HOPE CREEK GENERATING STATION
DOCKET NO. 50-354
DRAFT SAFETY EVALUATION REPORT
OPEN ITEM STATUS

Enclosed for your review and approval (see Attachment 4) are the resolutions to the Draft SER open items, NRC questions and structural audit items listed in Attachment 3.

Public Service Electric and Gas Company hereby submits the enclosed responses to DSER open items, NRC Questions, Structural Audit items, and NRC requests for additional information for the Hope Creek Generating Station.

LOAD/SETTLEMENT PLOT FOR MARKER NO. 5

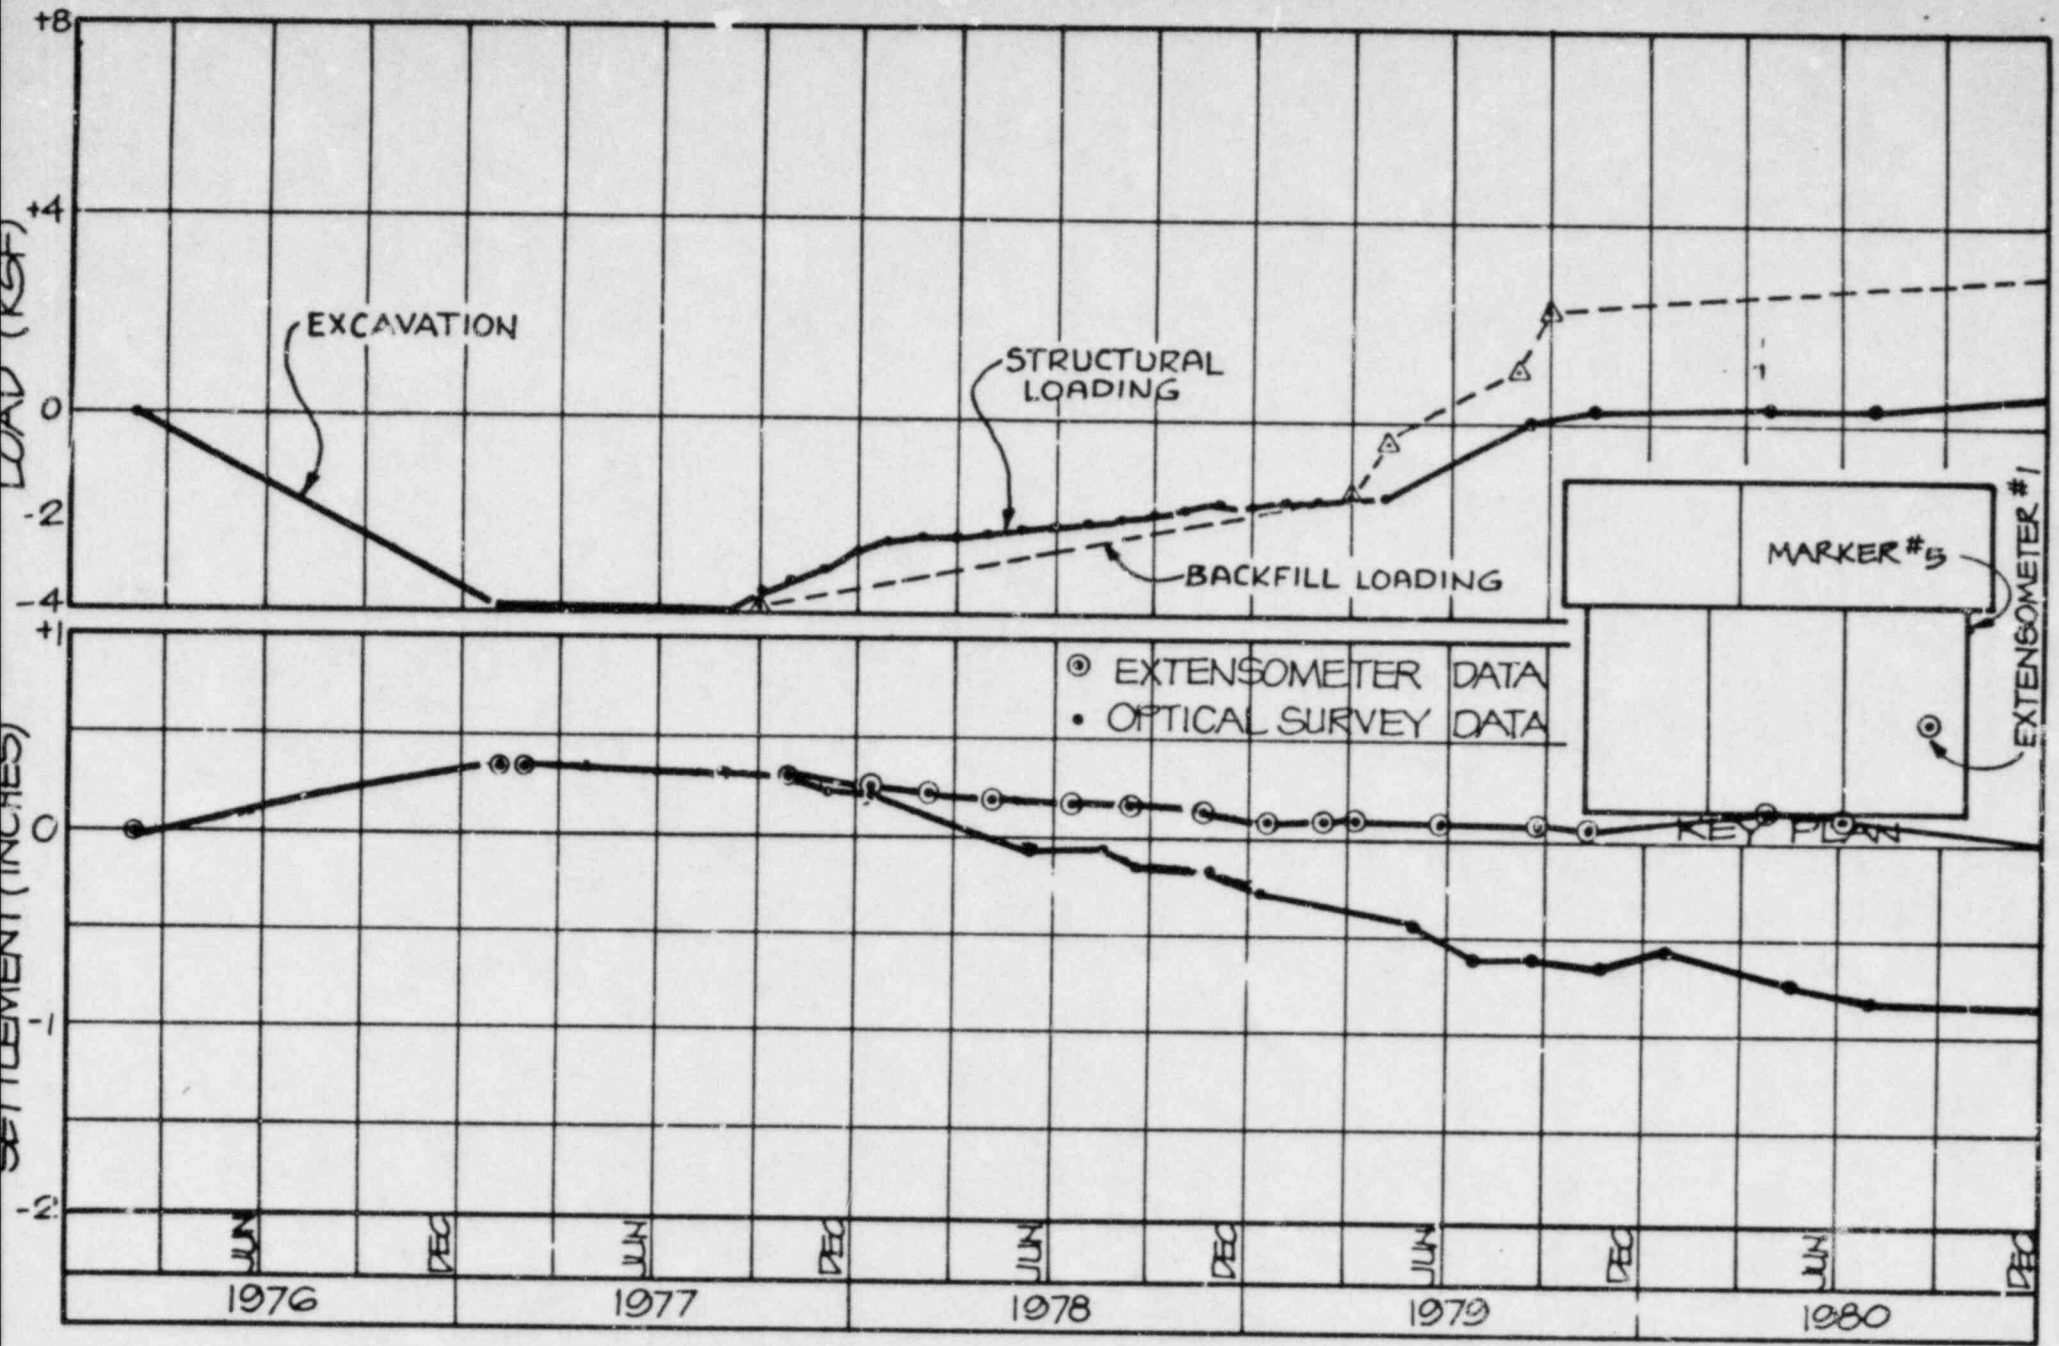
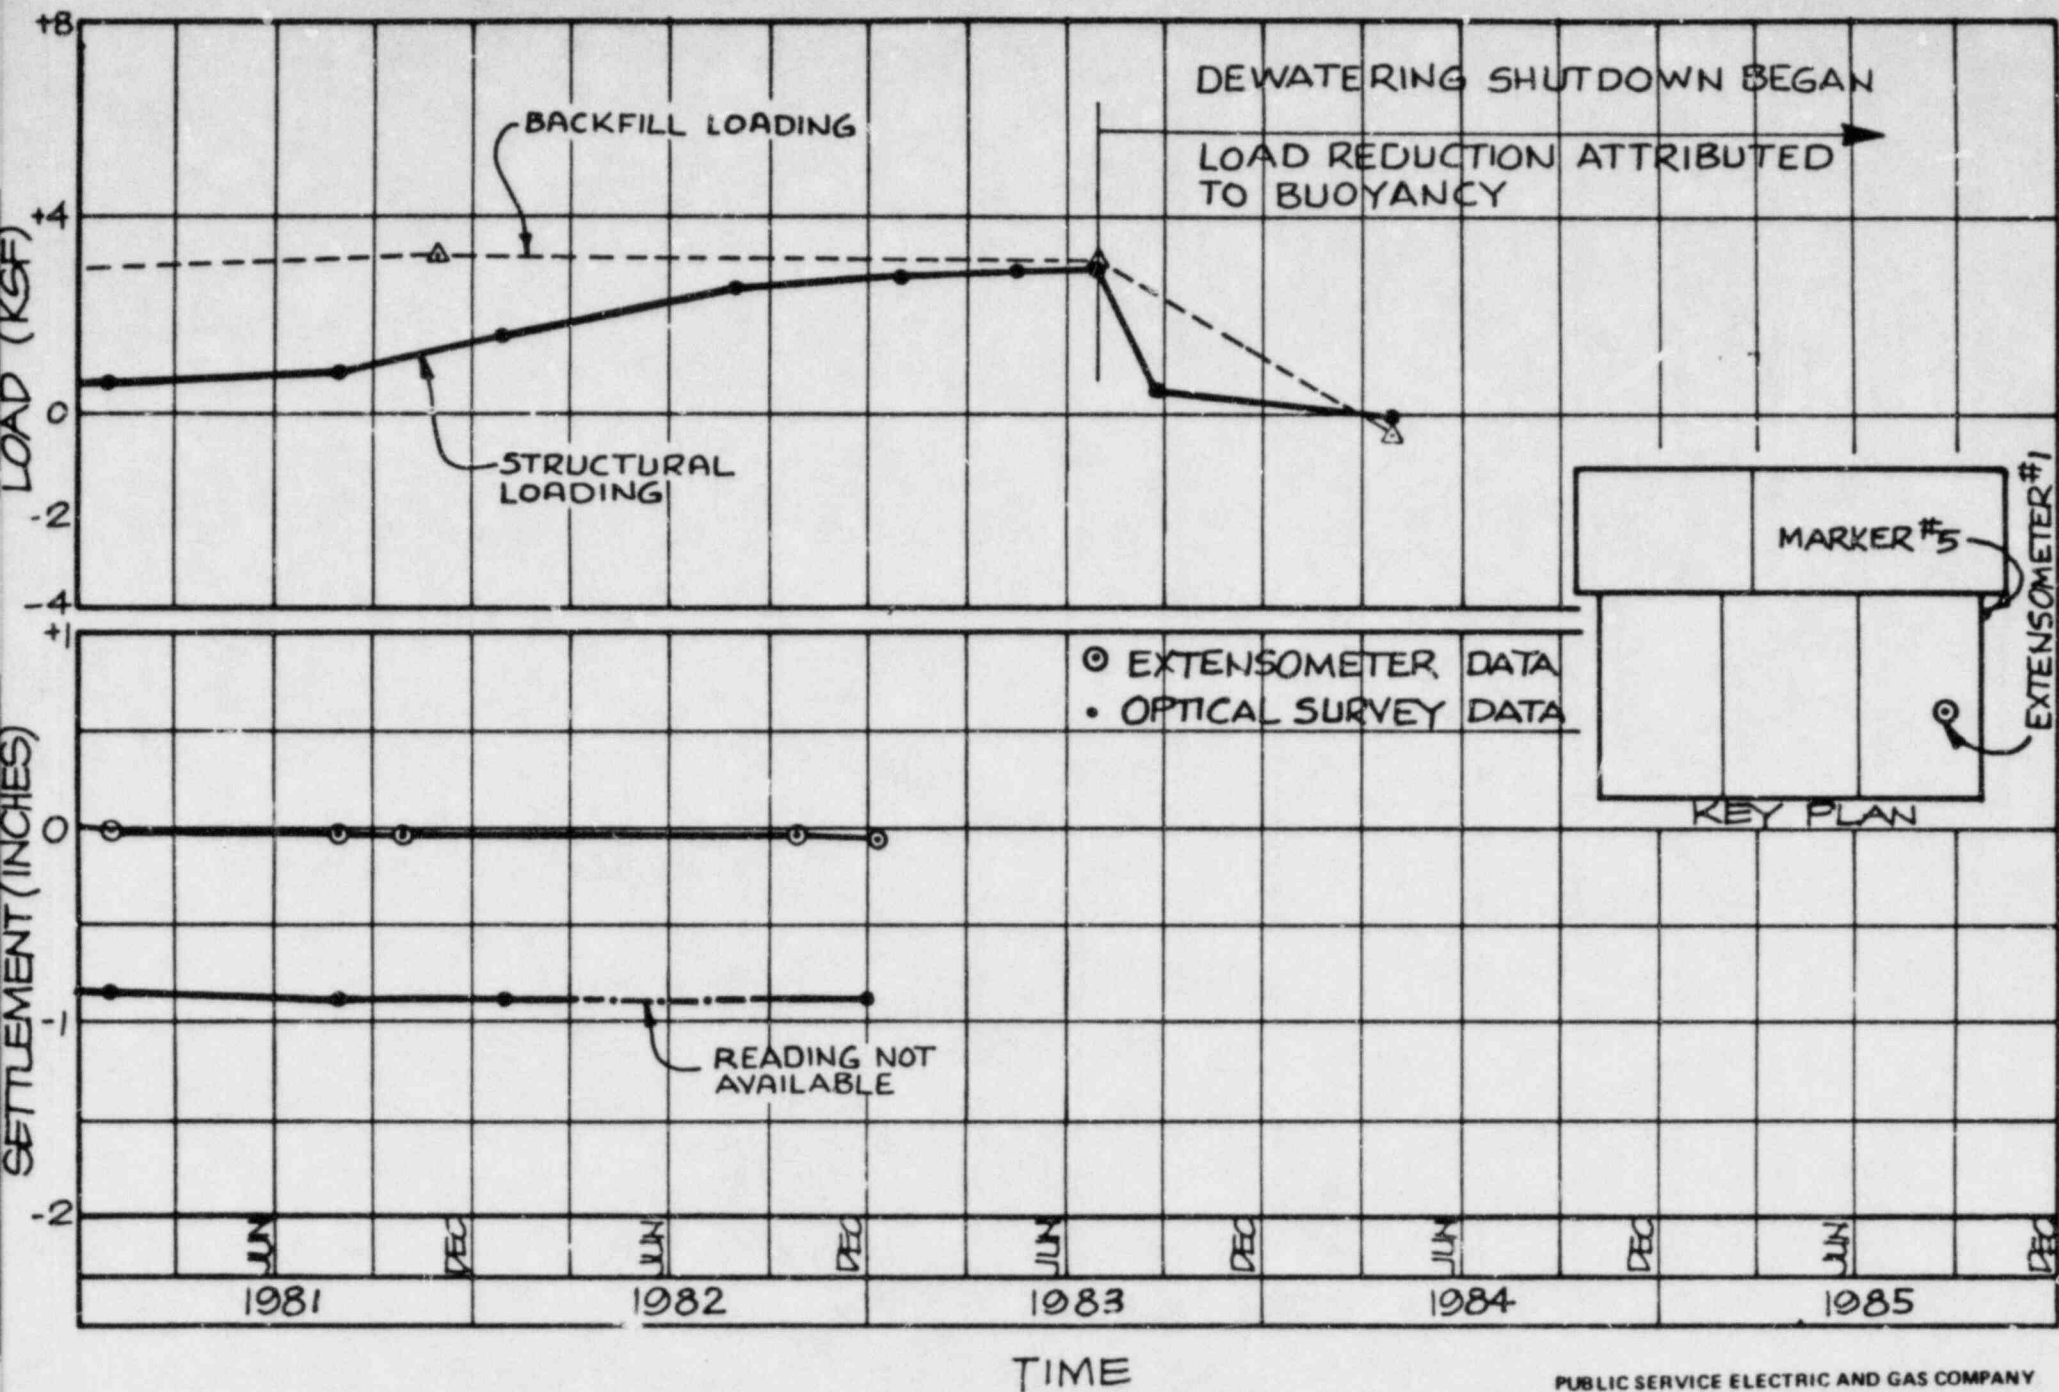
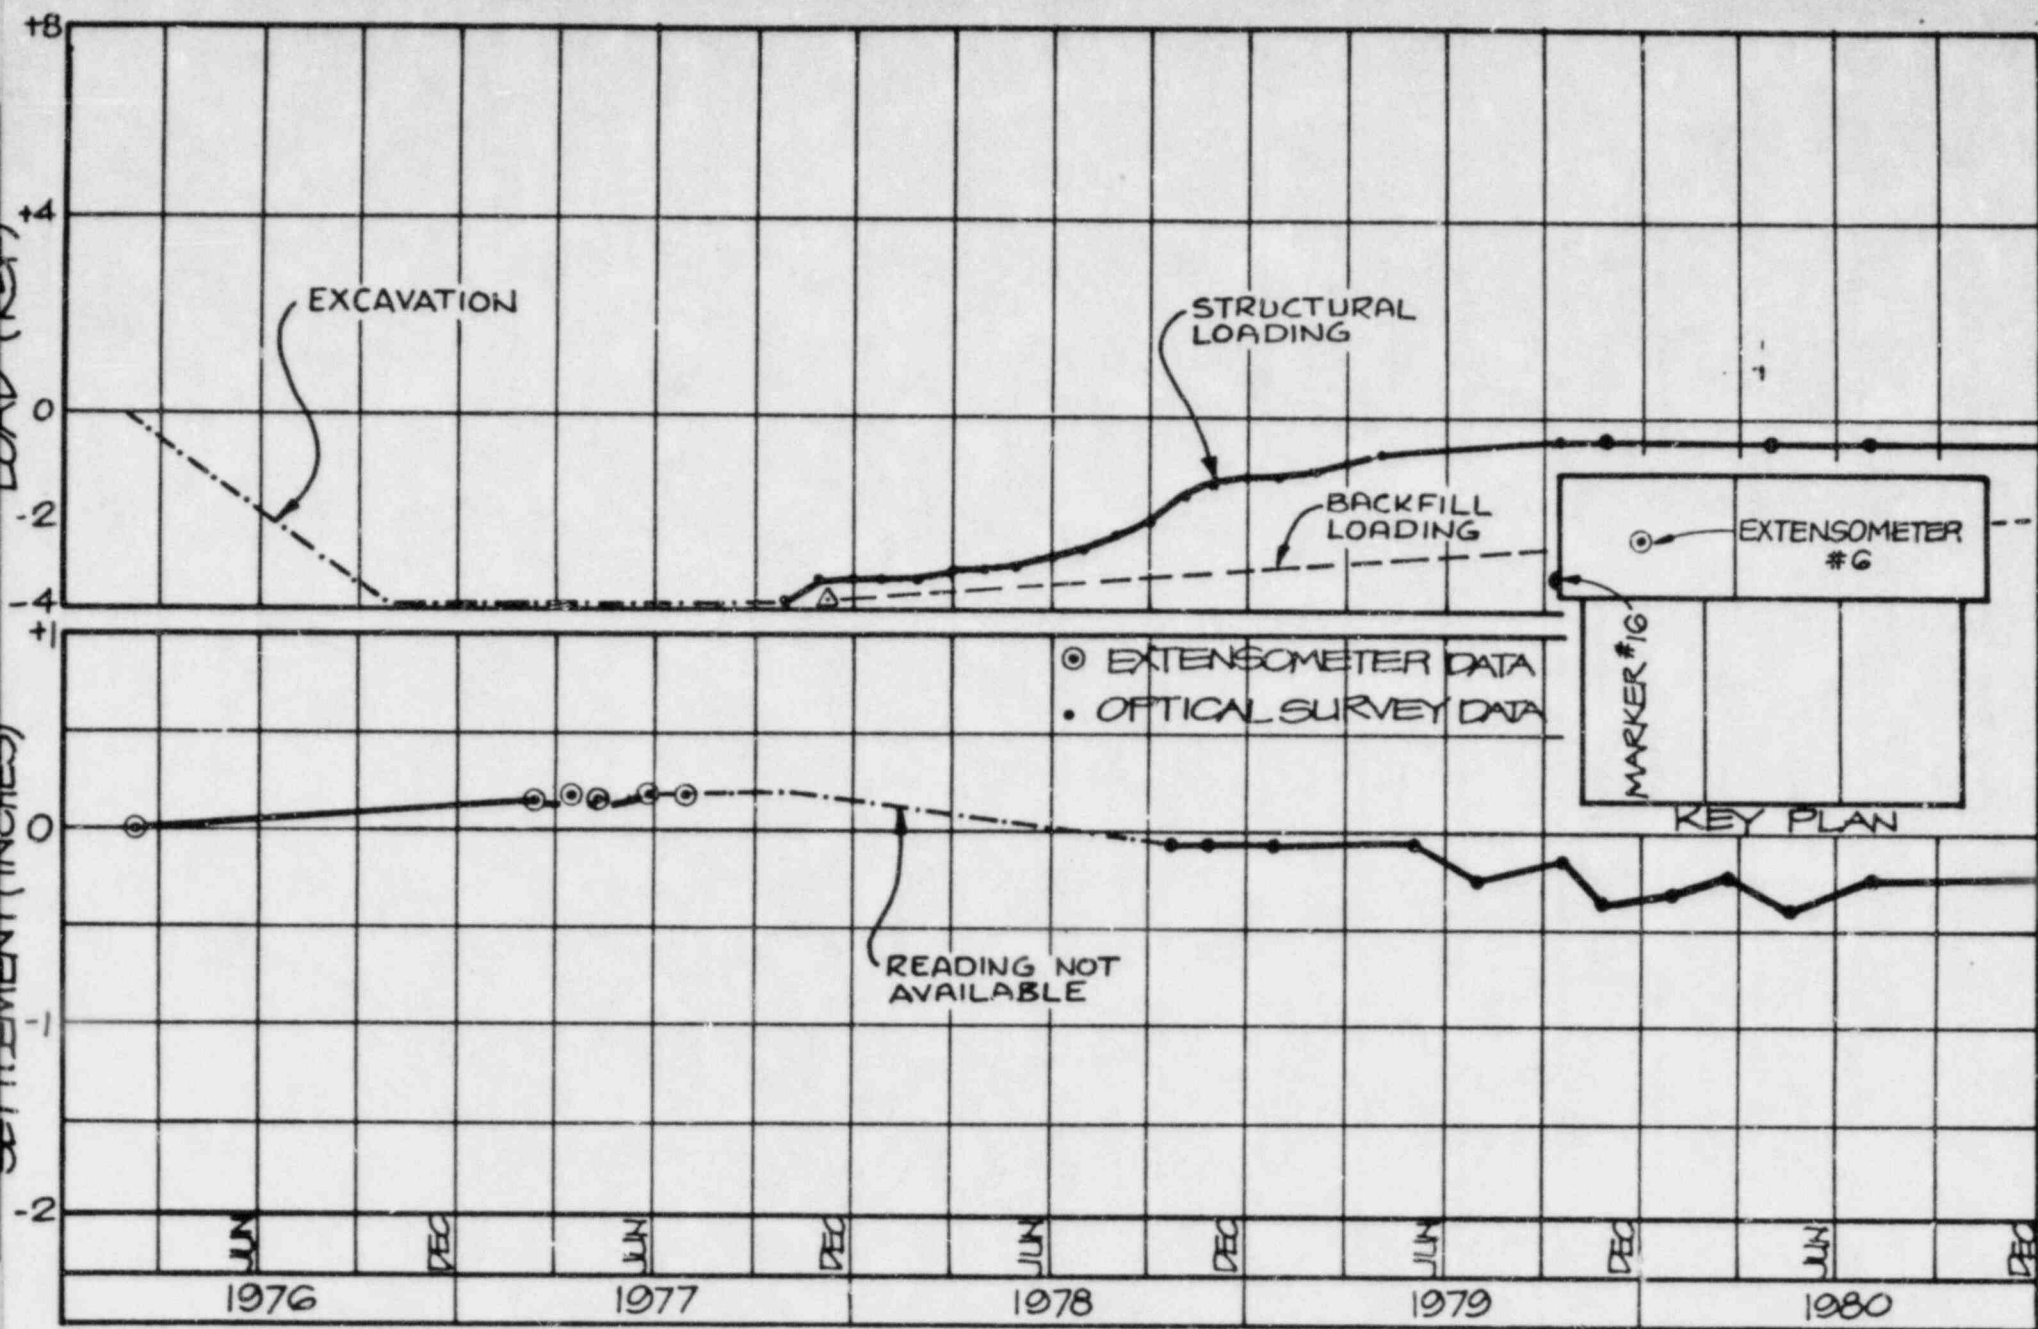
In justification of the statement ^{are} that the settlements measured at marker Nos. 16, 18 and 19, ~~and~~ due to the surrounding backfill loads, given in response to FSAR Question No. 241.25, revise the settlement plots for marker Nos. 3, 5, 16 and 18, as follows:

- o Add the loading history due to backfilling operation
- o Show the effect of decommissioning the dewatering system

The load/settlement plots for markers Nos. 3, 5, 16 and 18, have been revised to include effects of the backfilling and decommissioning of the dewatering system. The revised plots are attached in Figures 1 to 4.
